## Product Change Notice

Issue Date: 8 Feb 2024

LED supplier change for Smart Display AllnGaP Deep Red devices

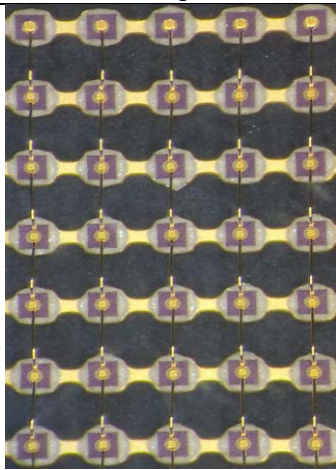
LED supplier change. No change to the product performance, except for the physical appearance and dimensions of the LEDs.

Existing LED	New LED
Appearance		
Dimension	9 mil x 9 mil x 7 mil	8 mil x 8 mil x 6.7 mil
